9800 Medical Center Drive, Site Plan Amendment and Final Water Quality Plan No. 81995045G

Completed: July 1, 2021

- **Site Plan:** Request to amend a previously approved Site Plan for the development of an additional 93,560-square-foot lab/office building and a 244-car parking garage, with stormwater management and landscape planting improvements;
- **Water Quality Plan:** Request to revise Final Water Quality Plan to allow for the addition of 37,410 square feet of new impervious surfaces;
- **Location:** Northwest quadrant of the intersection of Darnestown Road and Shady Grove Road in Rockville.
- **Tract Area:** Approximately 18.14 acres of land zoned LSC; within the 2010 *Great Seneca Science Corridor Master Plan* area, and the Piney Branch Special Protection Area (SPA);
- **Applicant:** ARE Maryland No. 24, LLC;
- **Acceptance date:** April 29, 2021;
- **Review Basis:** Chapters 59 and 19.

Figure 11: Remaining Design Issues

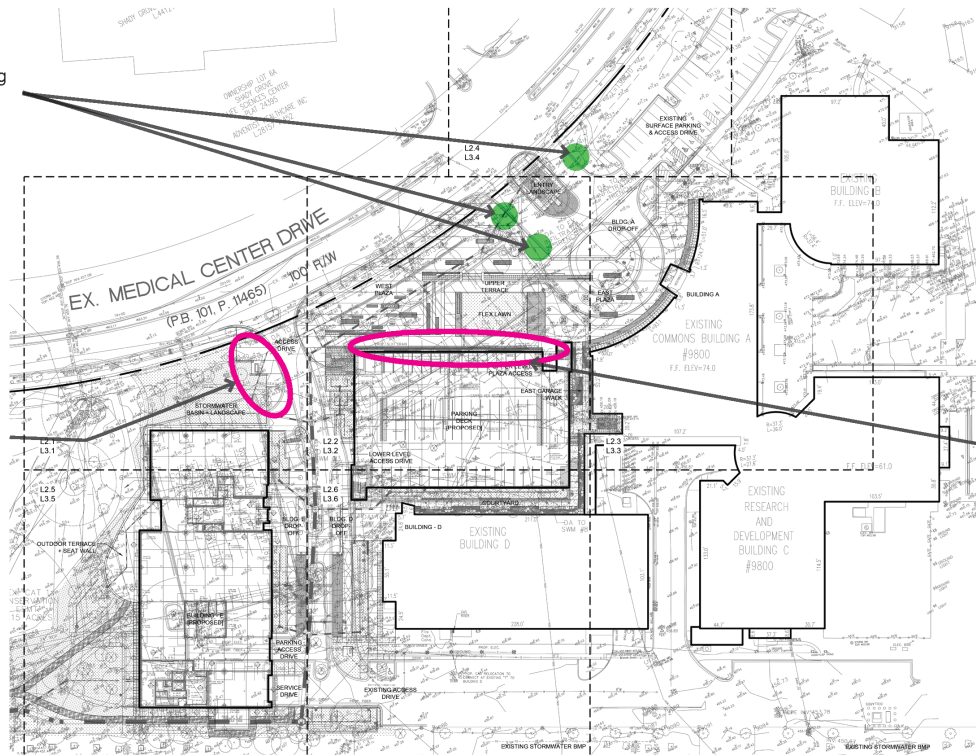
Provide more trees along drop-off area.

Design of the plaza to better screen the parking at ground level off building E, create a gateway iconic signage and create a trail head leads to the forest conservation area to the west.

Provide more intensive and varied landscaping at the base of the garage facing the plaza, similar to landscape provided in the narrow courtyard between the proposed garage and building D.

There are three design issues to be addressed at time of Certified Site Plan:

1. The plantings at the base of the proposed parking garage should include a greater variety of plants, creating a more pedestrian scale experience.
2. Additional trees should be added along the drop-off loop to emphasize the entrance and separate pedestrians from vehicles.
3. The design of the small western plaza along Medical Center Drive should be improved to better screen the parking at ground level of Building E, create a gateway iconic signage, and create a trail head that leads to the forest conservation areas to the west.

FIRE ACCESS PLAN

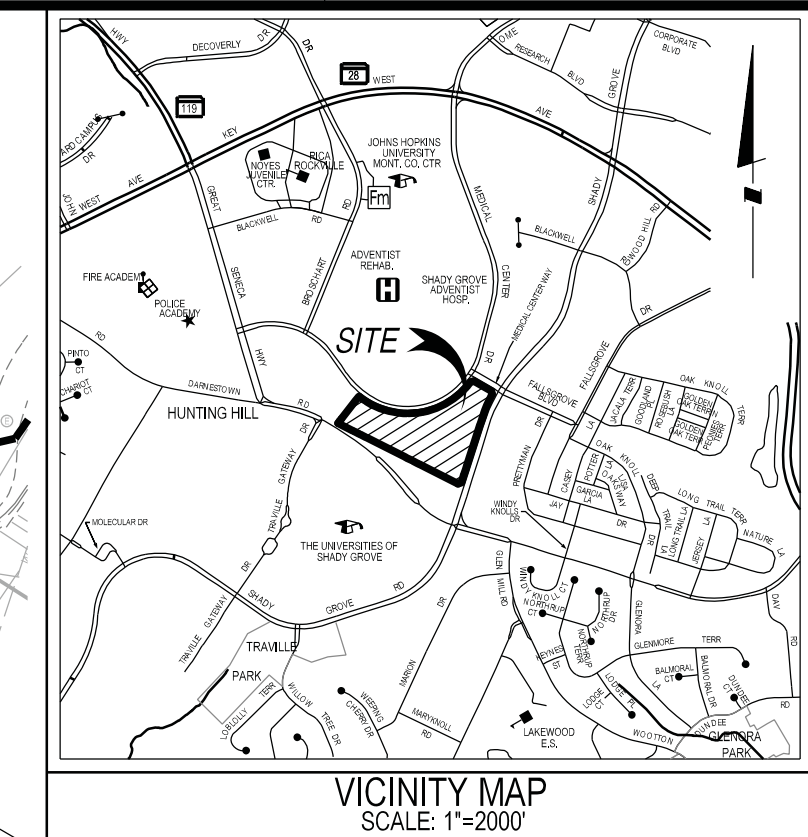
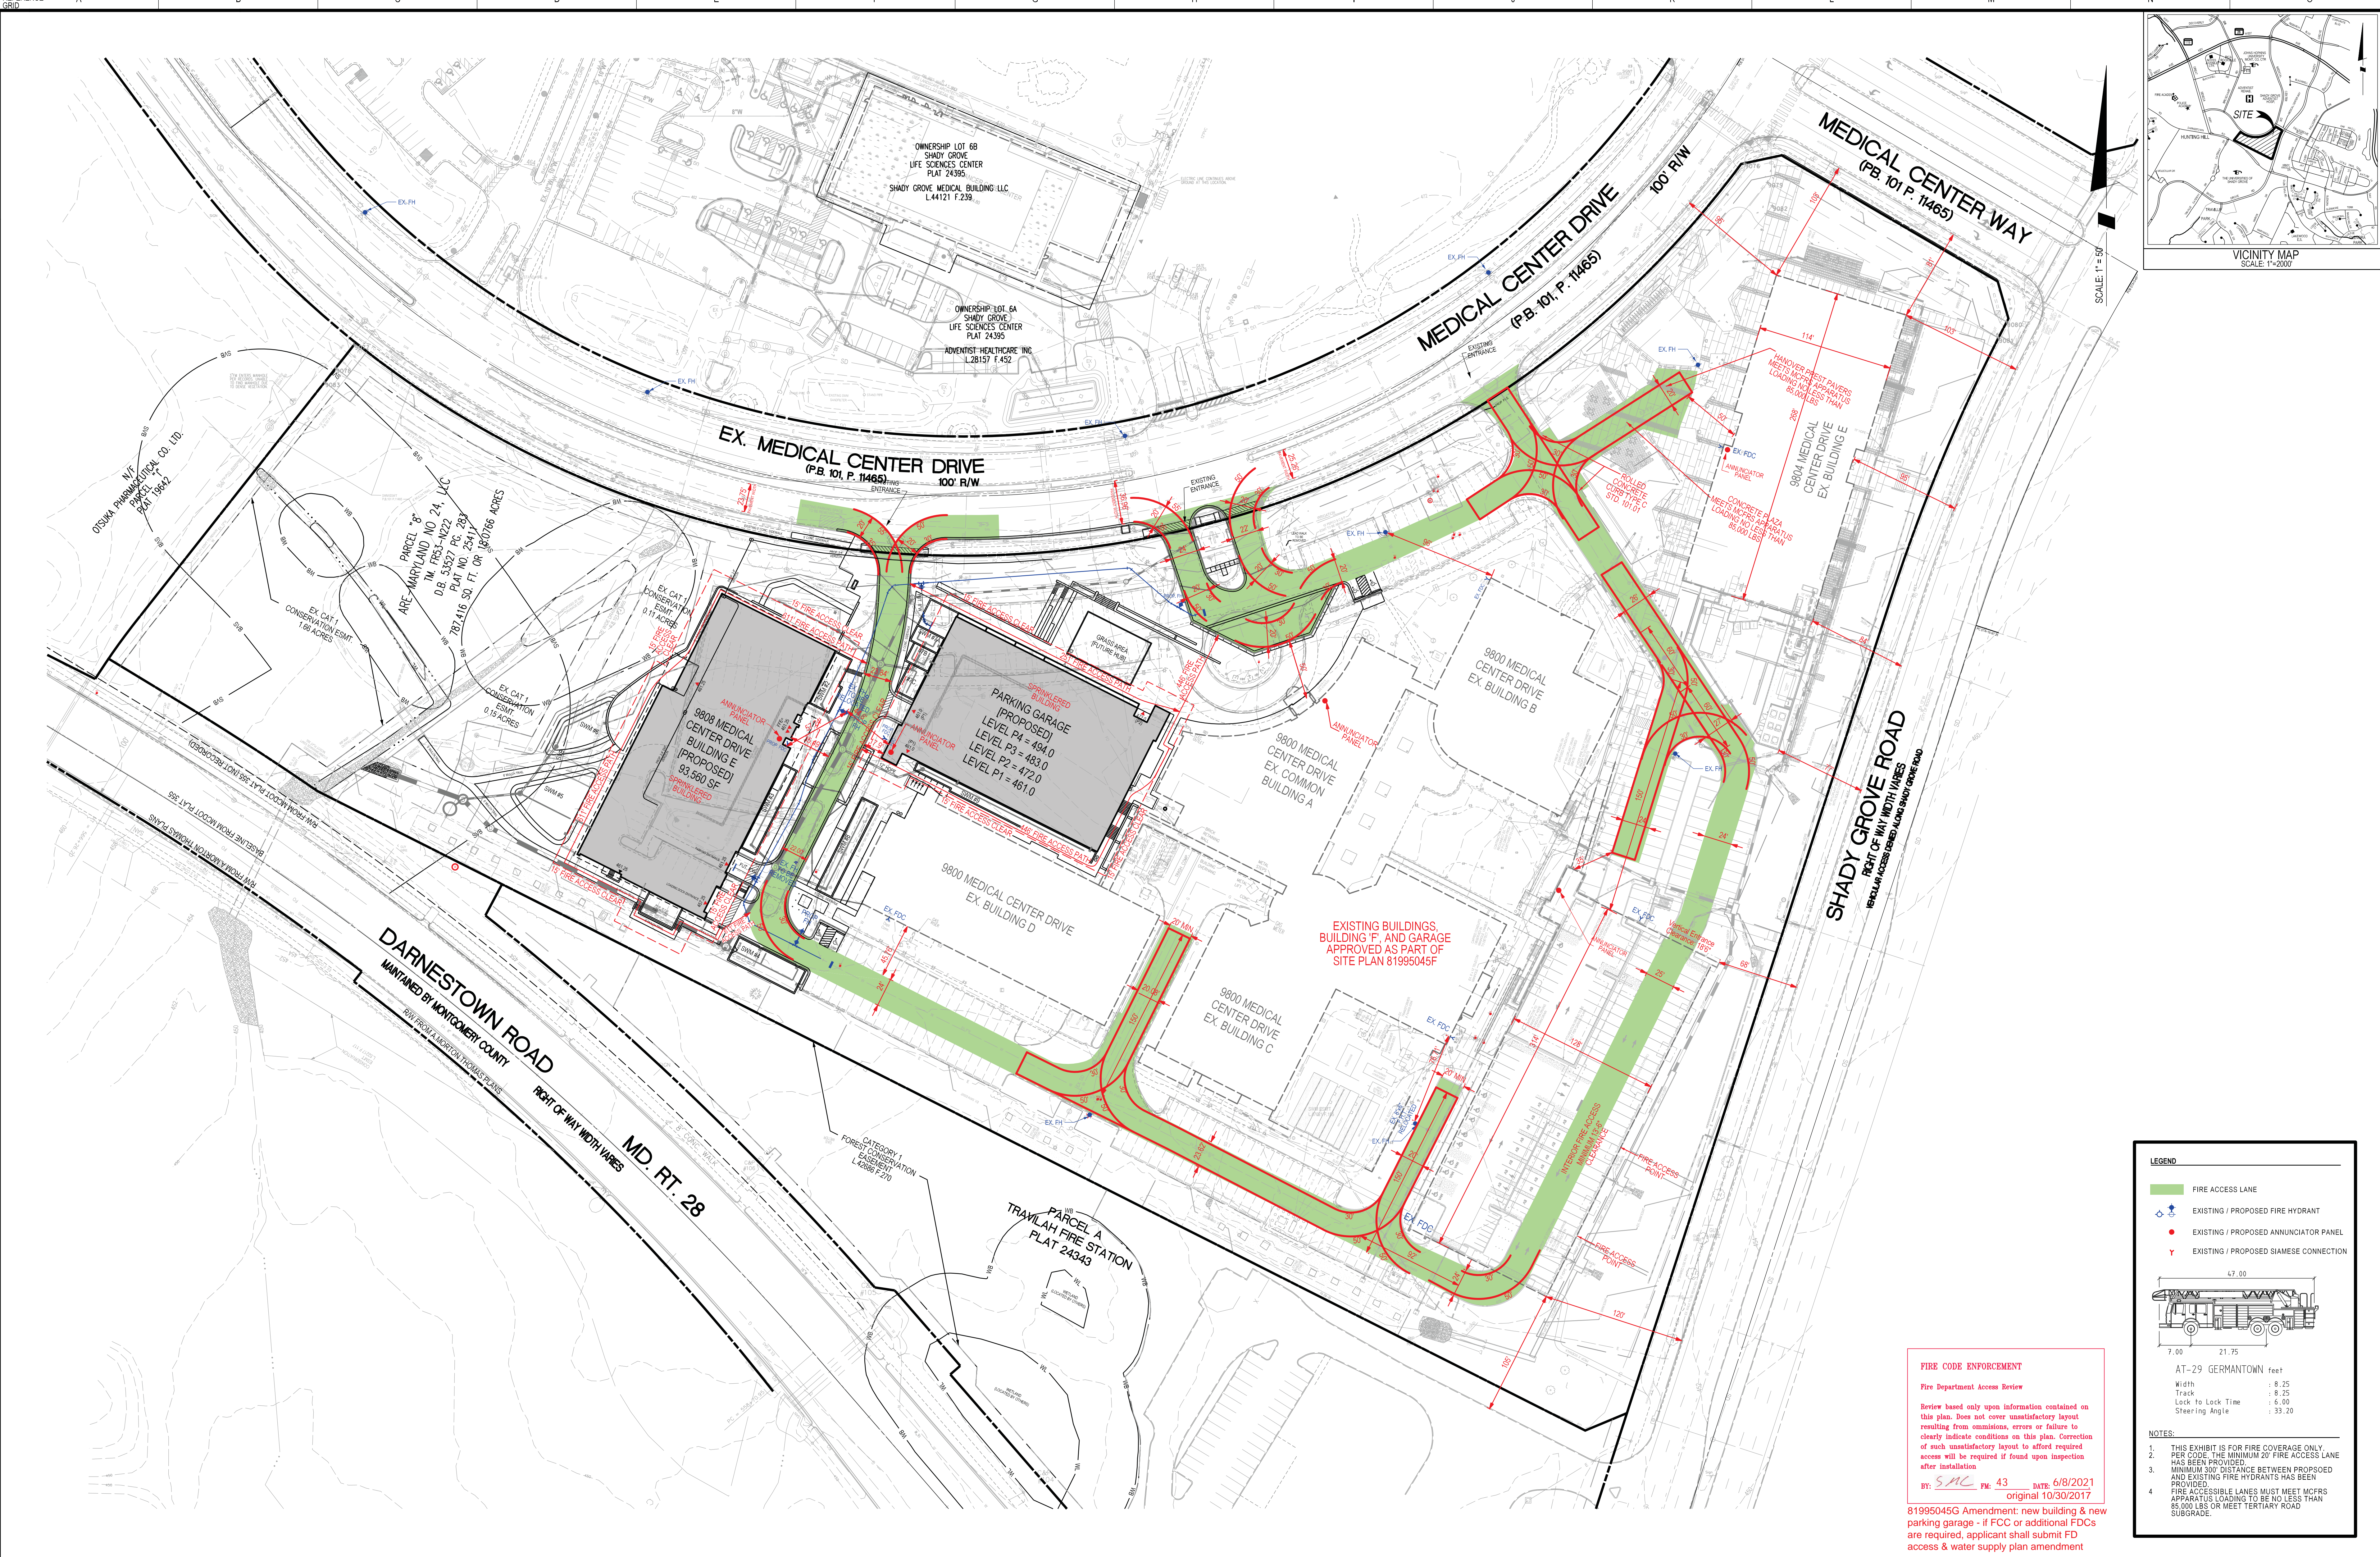
***** 1/16/2018 Amendment to FDC locations, plaza pavement scoring pattern, & parking layout changes ONLY. Any other alterations were not reviewed as part of this amendment *****

***** 6/8/2021 81995045G Amendment: new building & new parking garage - if FCC or additional FDCs are required, applicant shall submit FD access & water supply plan amendment *****

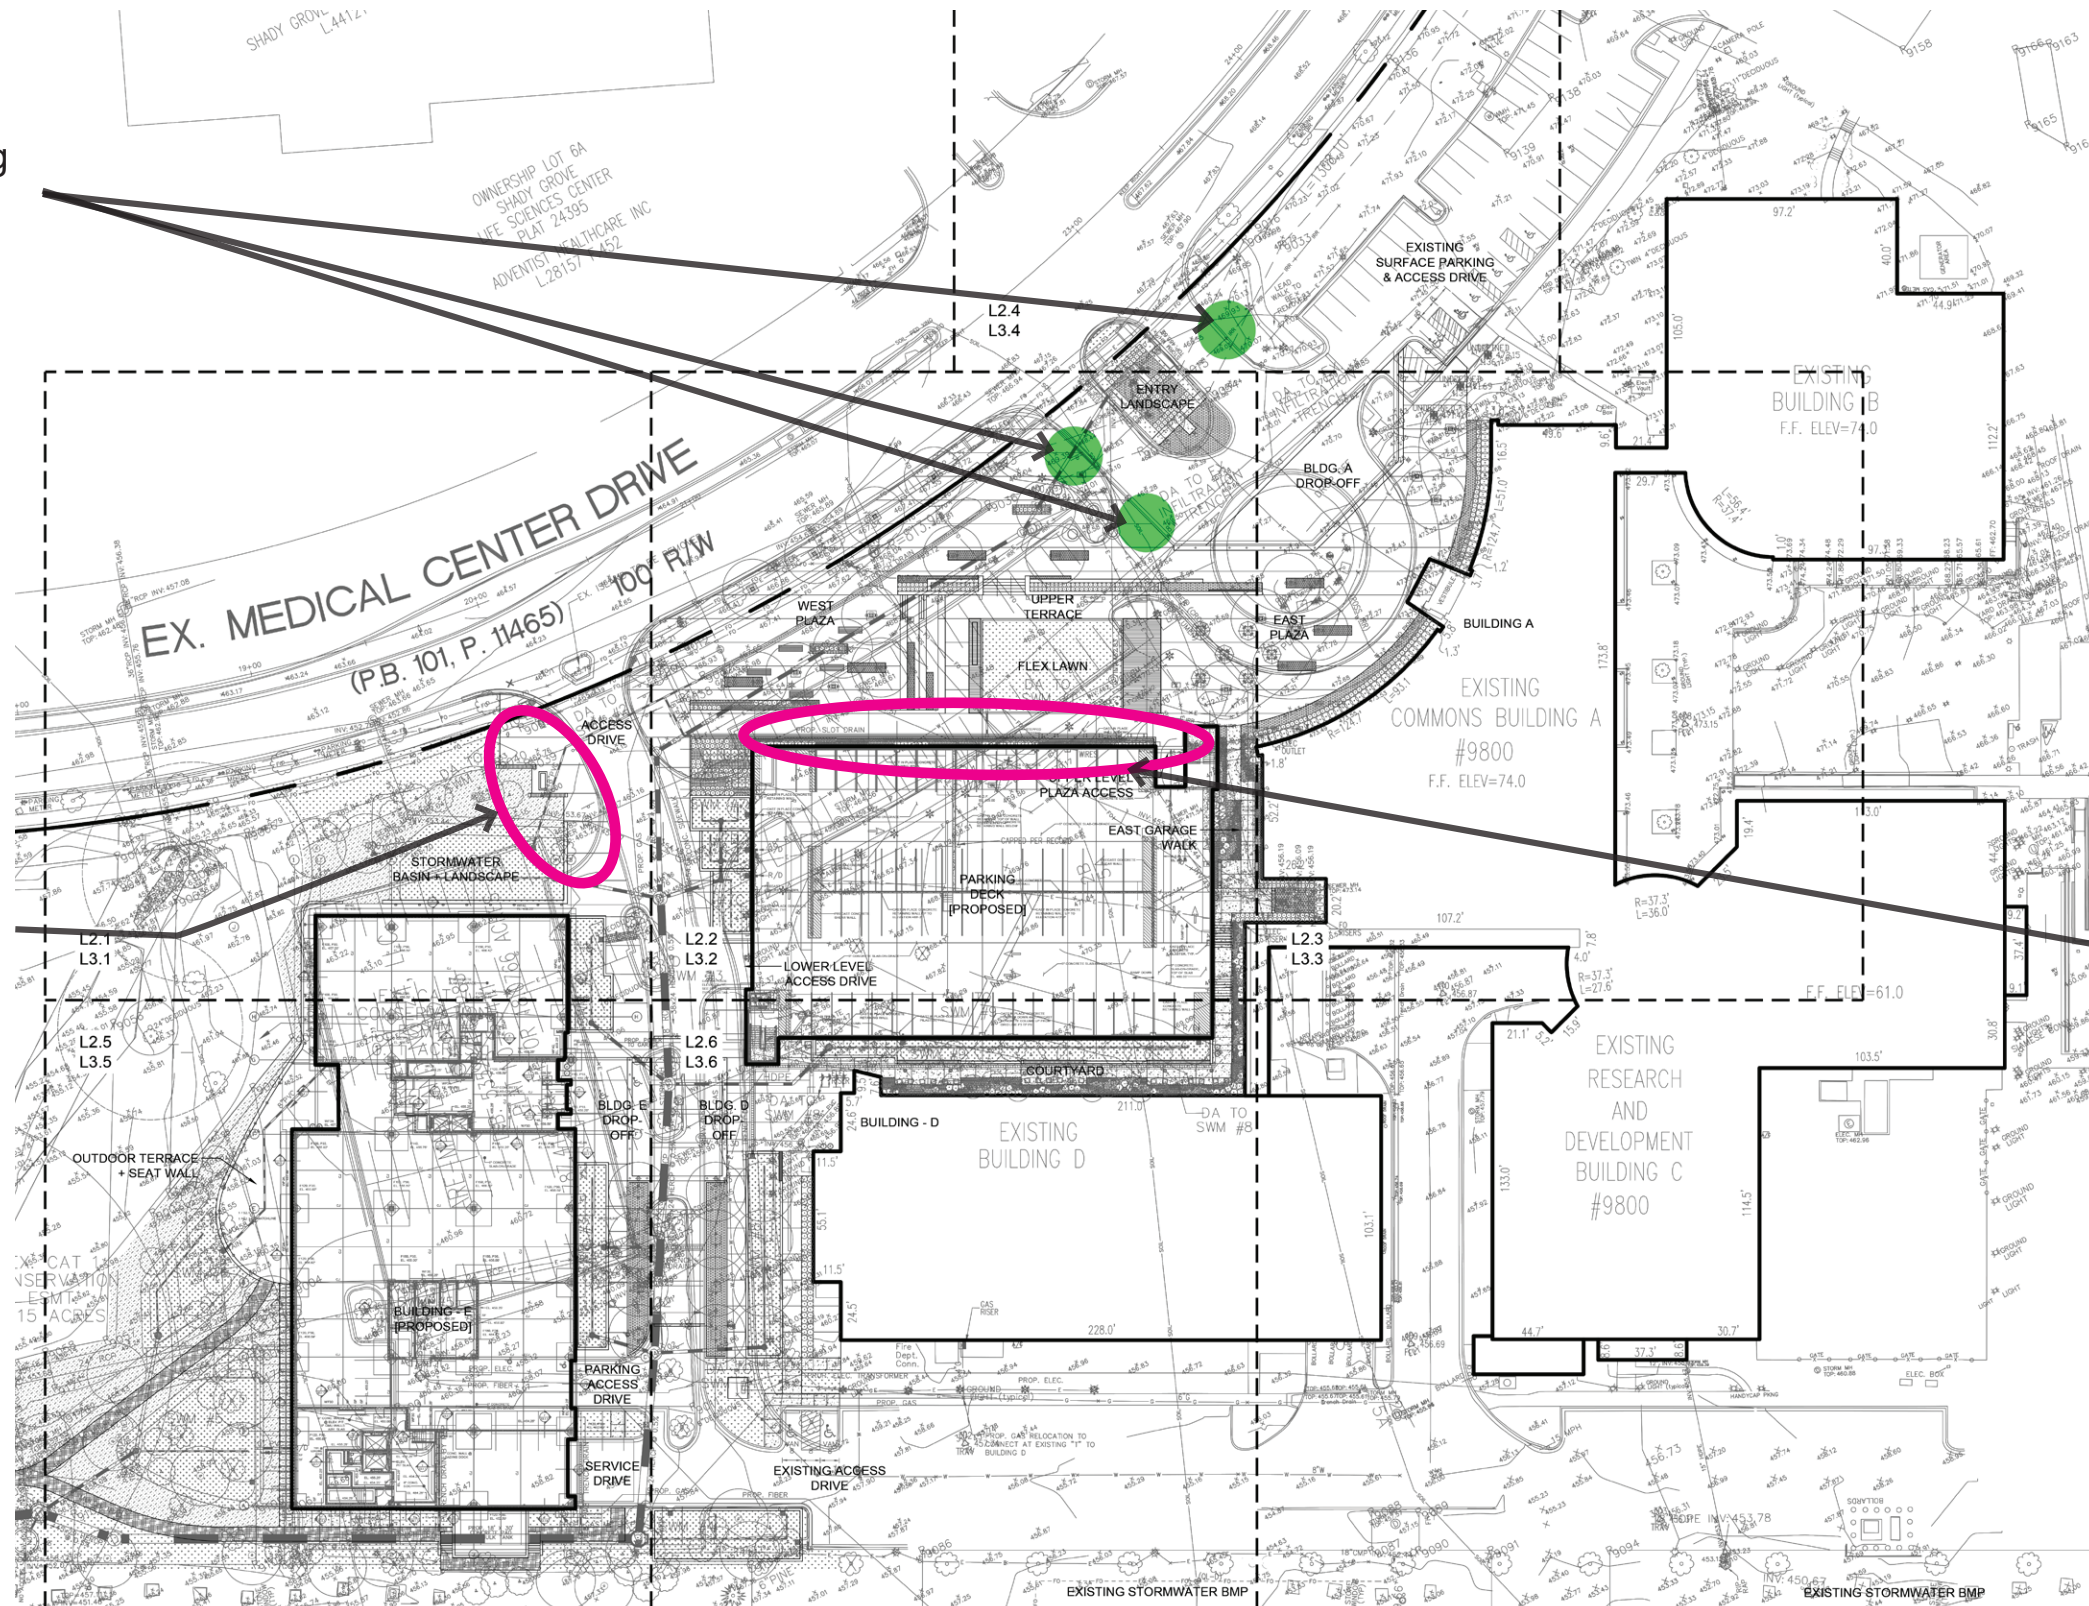
Provide more trees along drop-off area.

Provide more intensive and varied landscaping at the base of the garage facing the plaza, similar to landscape provided in the narrow courtyard between the proposed garage and building D.
